**APPENDIX E**  
**PACDIV COMMENTS AND WILLBROS RESPONSES**

PACDIV REVIEW COMMENTS  
PH-PACDIV 10-11012/4 (Rev. 11-93)

PROJECT TITLE	CONTRACT NO.	DATE	PAGE	OF
FIRE/RISK ASSESSMENT STUDY, RED HILL TUNNEL COMPLEX	N62742-89-C-0069	28 Sep 94	1	4
		DD FORM 1391	DESIGN CRITERIA	
		PRELIM. PLANS	FNL SPCS & PLNS

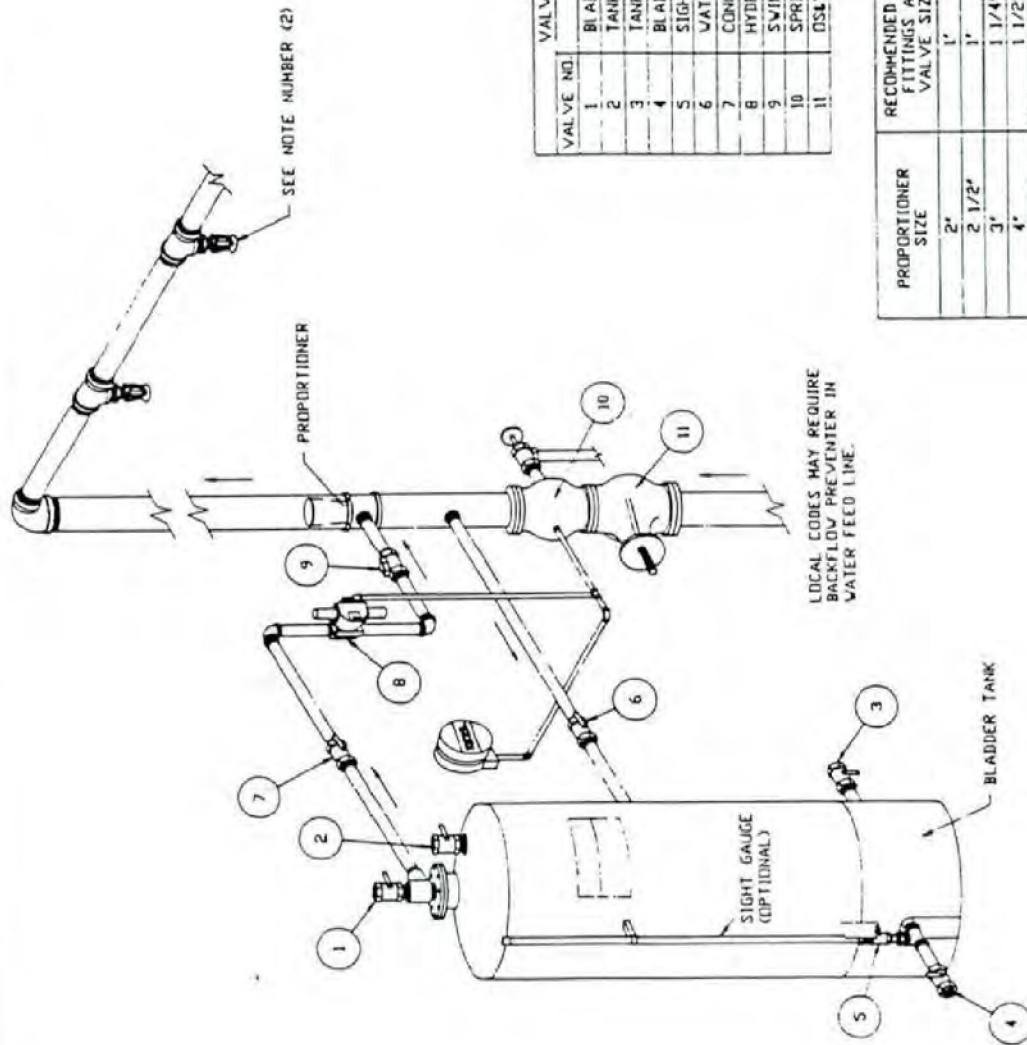
DWG NO. OR SPEC PARA. NO.	ITEM NO.	COMMENTS	ACTION
P. 4-31	9	Section 4.6.2.9, Fire Suppression: a. Provide a concept sketch of the recommended AFFF deluge system.	see Exhibit 4-1
		b. Discuss why AFFF deluge system was selected, i.e., why not other alternative systems? Also, see comment item no. 1.6. above.	See Sectn. 4.2.15
P. 4-31	10	Section 4.6.2.10, Ventilation: a. See comment item no. 6 above.	
		b. 2nd sentence: is this bulkhead door have an automatic closure device? Is one recommended/necessary?	Sectn. 4.6.2.10 revise
P. 4-32	11	Section 4.6.2.11: Please elaborate on this sentence: i.e., what kind of "centralized role" should FISC play in the Fire Protection Program? Their staffing is limited.	Sectn. 4.6.2.11 revised

Due to the quantity of fuel stored in the Red Hill complex and the potential for a fuel release in the lower tunnel, it is recommended that a fixed aqueous film forming foam (AFFF) fire suppression system be installed to provide protection for this area.

It is proposed that Critical Infrastructure 600 gallon 3% AFFF bladder tank pressure proportioning systems be provided to supply foam solution to zoned open head deluge systems. The systems will be automatically actuated by rate compensation thermal detectors (to be provided under construction contract no. N62471-89-C-02416; Provide Fire Alarm System for Red Hill POL Fuel Storage Facilities).   detection/deluge zones are recommended as follows:
